Mindel House. Upper floors

LAYOUT REVISED TO IMPROVE LIVING SPACE
EXPOSED COLUMNS AND CAPITALS
- PICADILLY WAREHOUSE | PLANNING PRESENTATION 39

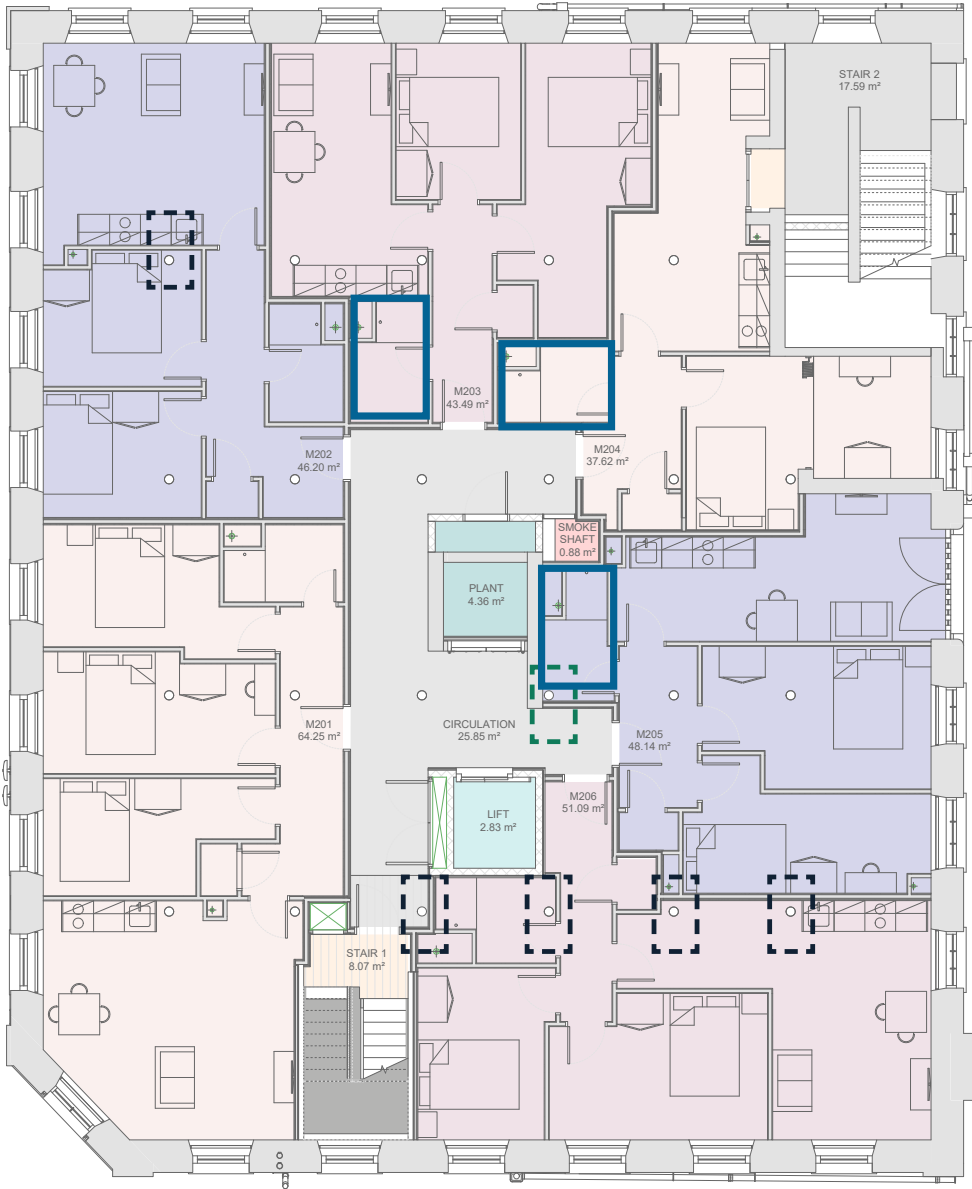
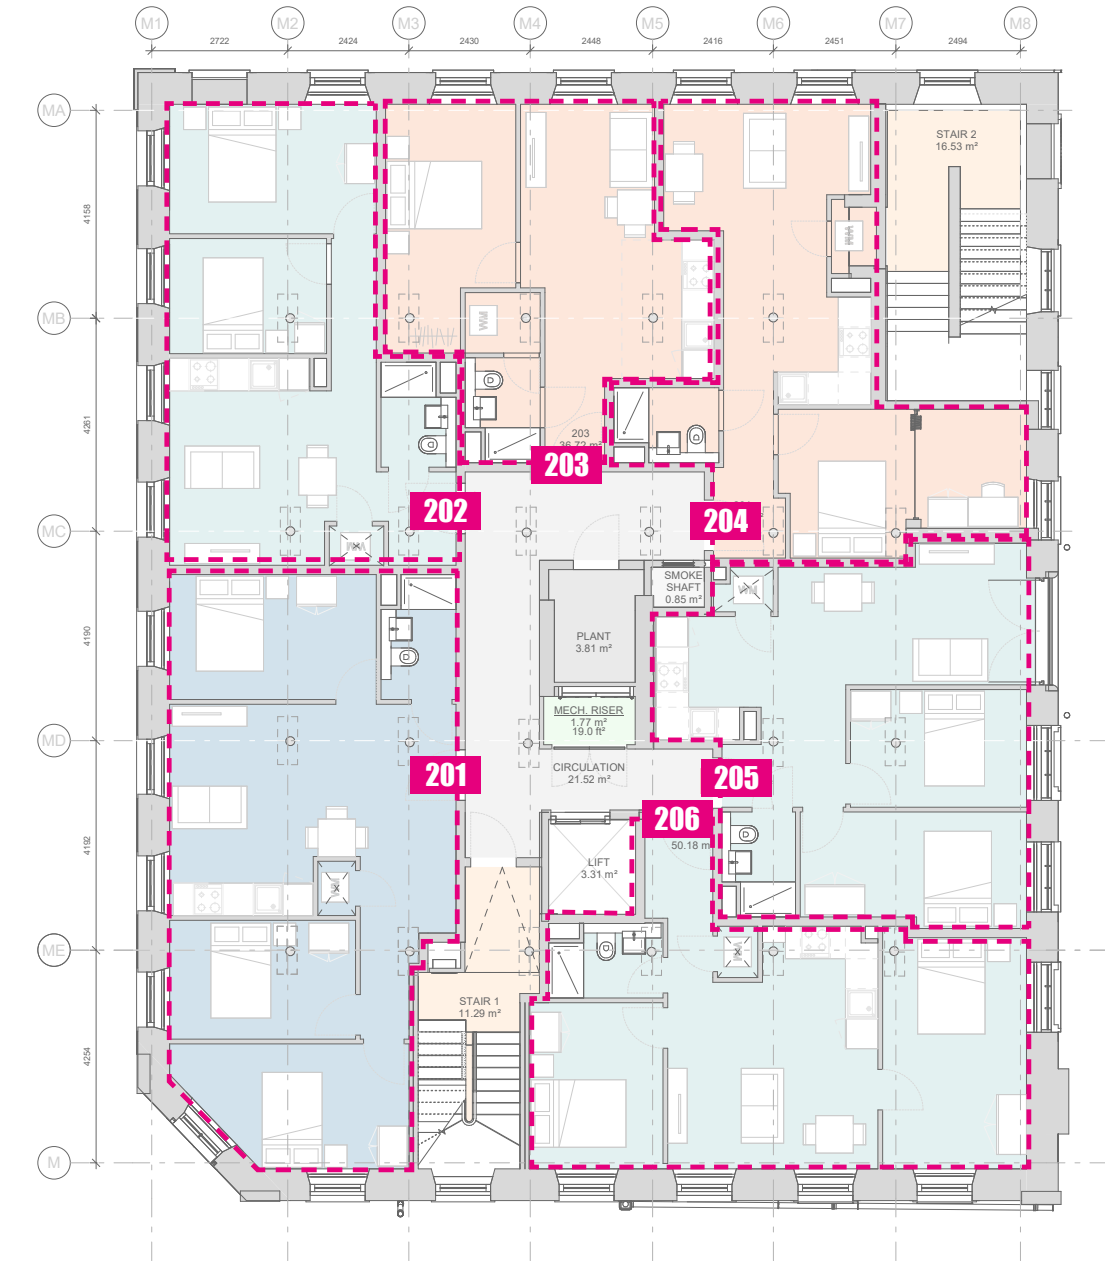
Clear width non compliant (less than 850mm)

Bathroom non compliant (typically too narrow)

Column capital clashing with wall

Layout Change

INVERTED KITCHEN/LIVING WITH BEDROOM LOCATION
OPEN PLAN ARRANGEMENT
EXPOSED COLUMNS AND CAPITALS
PARTITIONS NOT CLASHING WITH COLUMN CAPITALS
REDUCED CIRCULATION
- 202302402

OPEN PLAN ARRANGEMENT
INVERTED KITCHEN/LIVING WITH BEDROOM LOCATION

REDUCED CIRCULATION

PARTITIONS NOT CLASHING WITH COLUMN CAPITALS
EXPOSED COLUMNS AND CAPITALS

LAYOUT REVISED TO IMPROVE ADJACENT APARTMENT
REDUCED FROM 2 TO 1 BEDROOM
OPEN PLAN ARRANGEMENT

Bloom Street. Lower Ground Floor

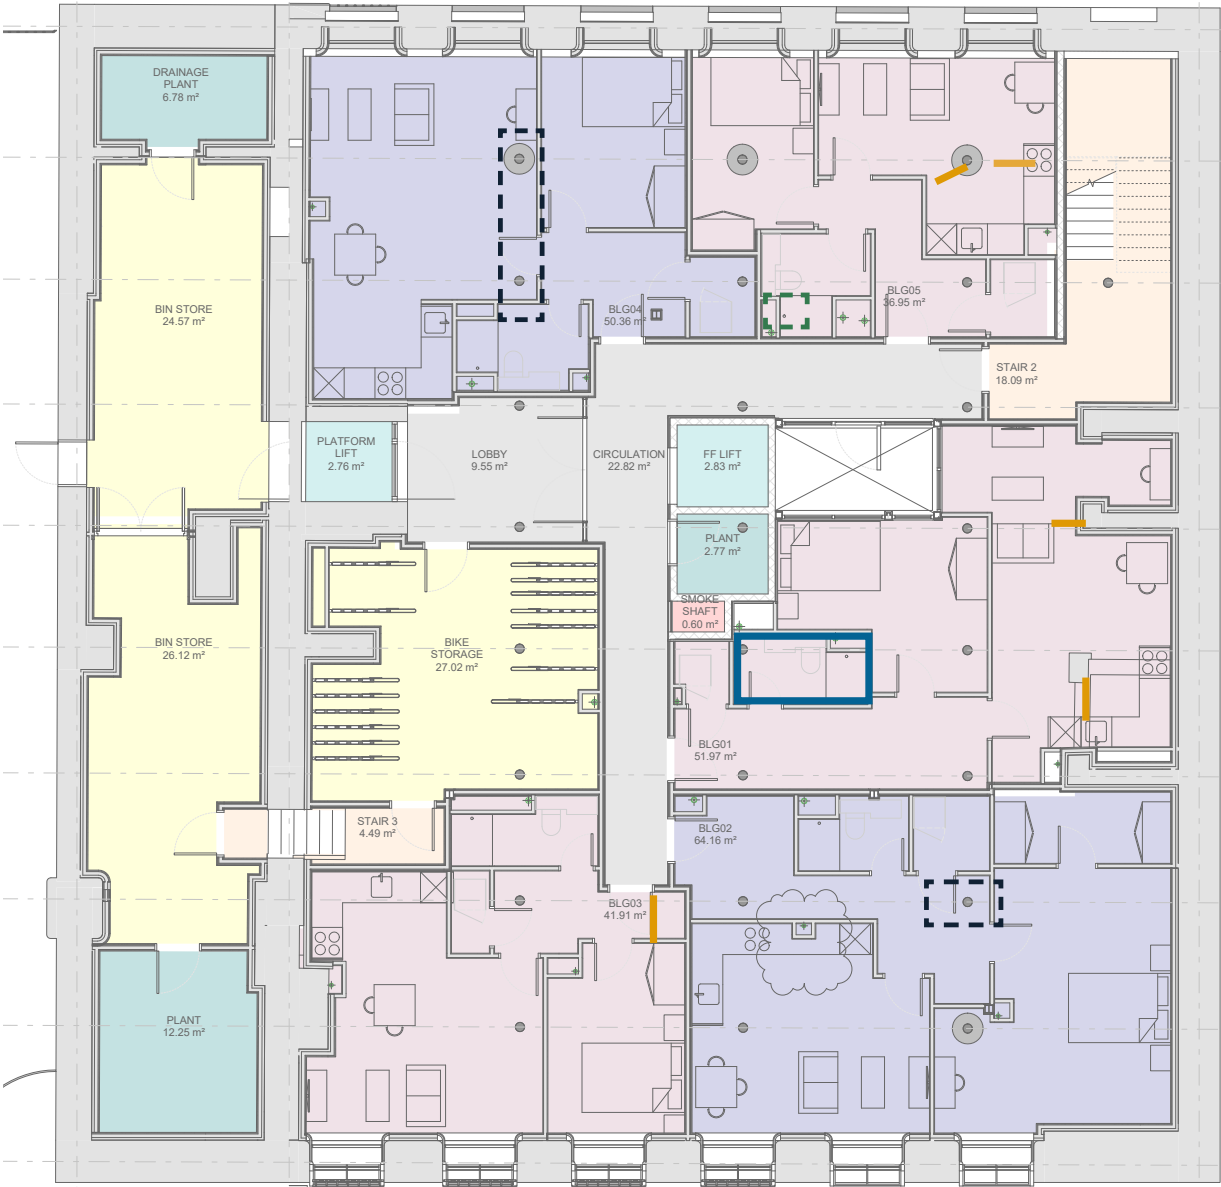
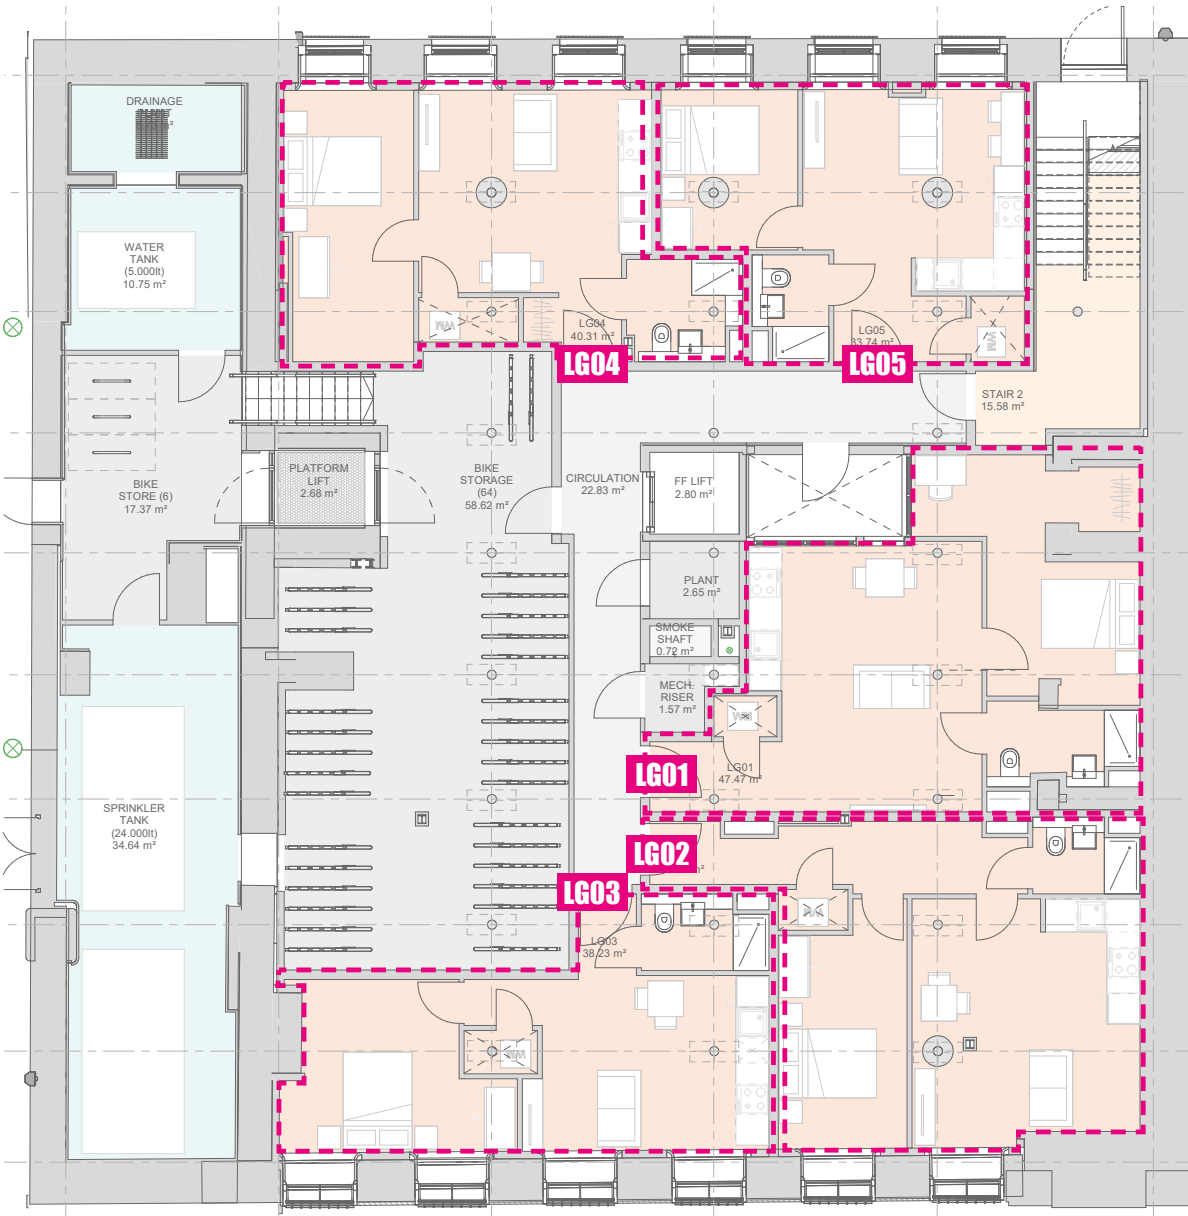
- Clear width non compliant (less than 850mm)
- Bathroom non compliant (typically too narrow)
- Column capital clashing with wall
- Layout Change

- LG01 OPEN PLAN ARRANGEMENT
IMPROVED KITCHEN/LIVING NATURAL LIGHT
INVERTED KITCHEN/LIVING WITH BEDROOM LOCATION
EXPOSED COLUMNS AND CAPITALS
- LG02
- LG03 LAYOUT REVISED FOLLOWING CYCLE STORE REDESIGN
OPTIMIZED LAYOUT
- LG04
- LG05 OPEN PLAN ARRANGEMENT
REDUCED CIRCULATION

Bloom Street. Upper Ground Floor

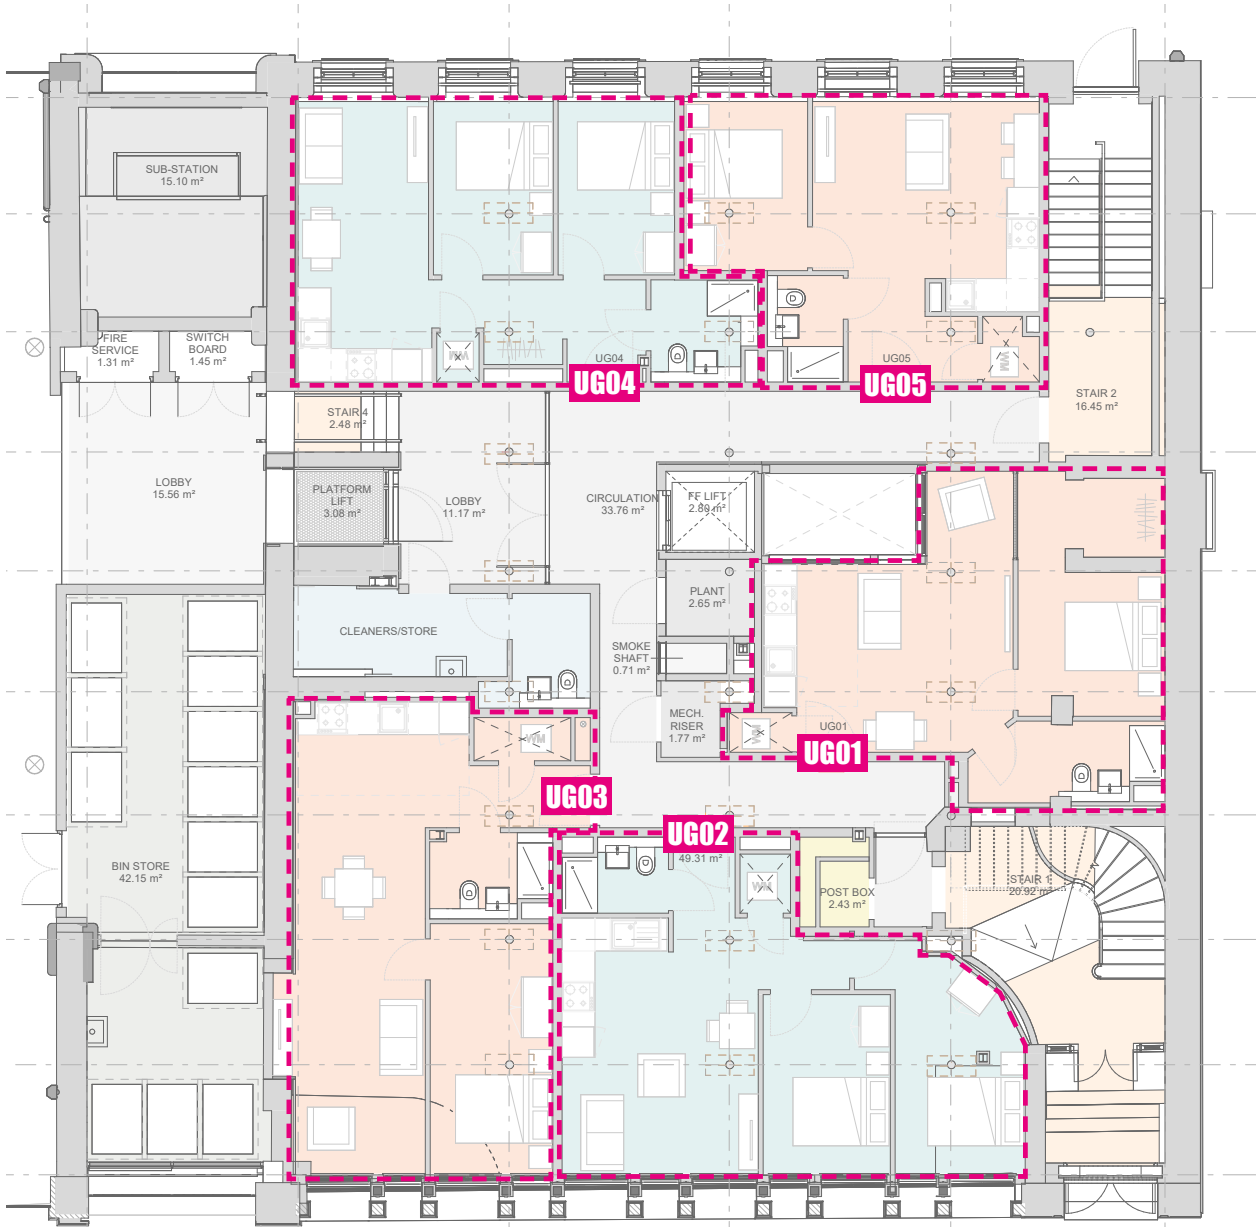
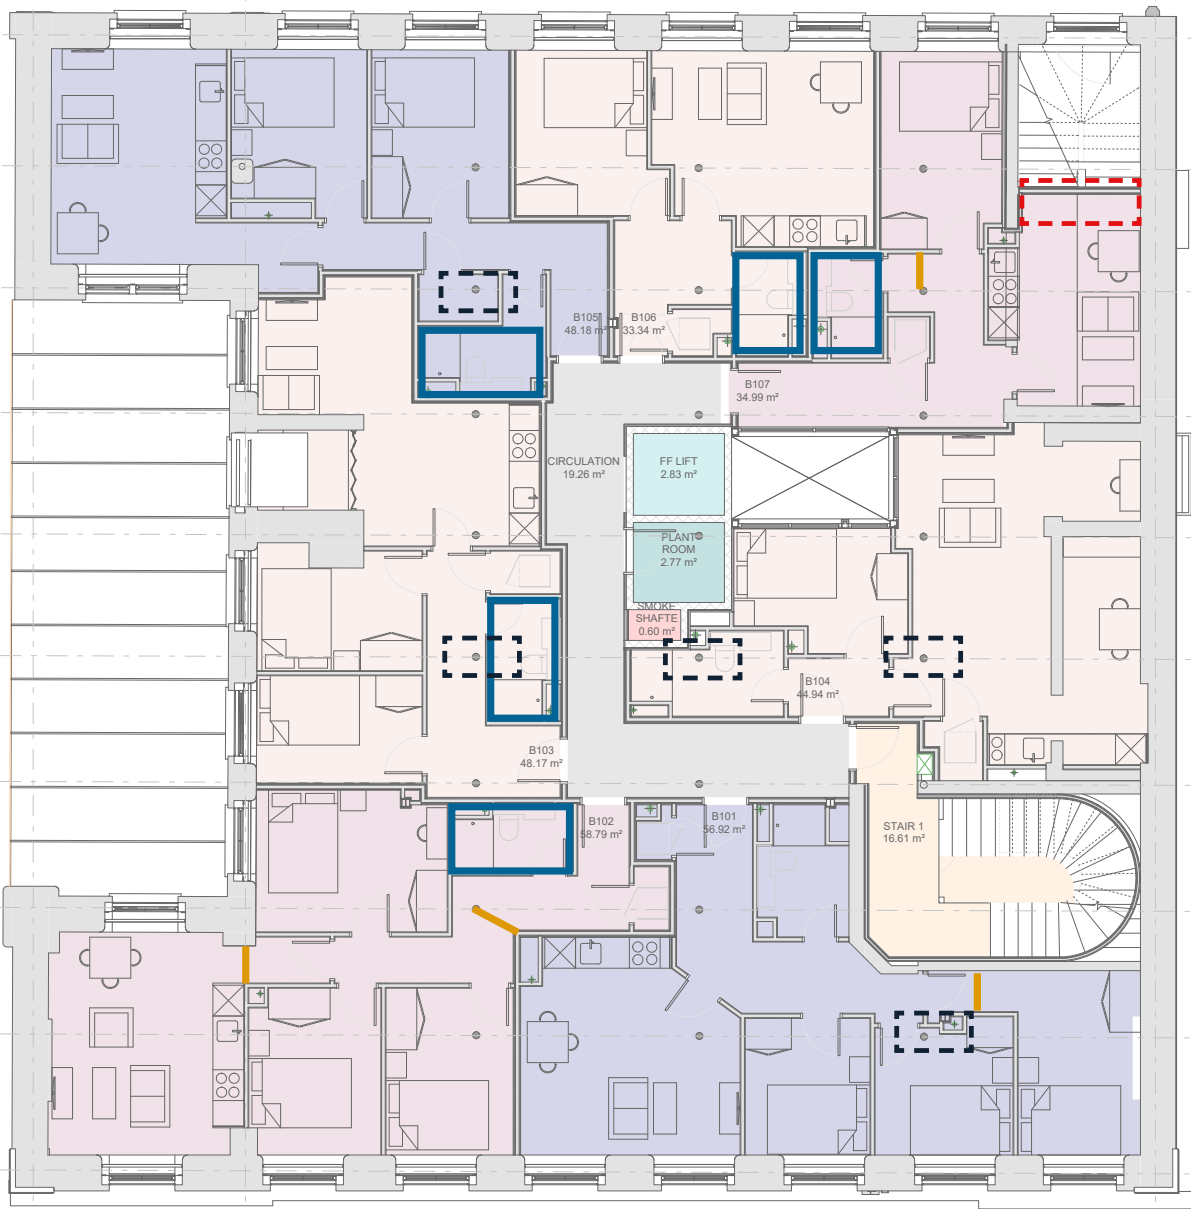
Clear width non compliant (less than 850mm)

Bathroom non compliant (typically too narrow)

Column capital clashing with wall

Layout Change

OPEN PLAN ARRANGEMENT
IMPROVED KITCHEN/LIVING NATURAL LIGHT
OPTIMIZED LAYOUT
EXPOSED COLUMNS AND CAPITALS

OPEN PLAN ARRANGEMENT
INVERTED KITCHEN/LIVING WITH BEDROOM LOCATION
EXPOSED COLUMNS AND CAPITALS

LAYOUT REVISED FOLLOWING WASTE MANAGEMENT STRATEGY
REDUCED FROM 2 TO 1 BEDROOM
OPEN PLAN ARRANGEMENT
EXPOSED COLUMNS AND CAPITALS

AREA REDUCED FOLLOWING SECONDARY STAIR RELOCATION

OPEN PLAN ARRANGEMENT
REDUCED CIRCULATION
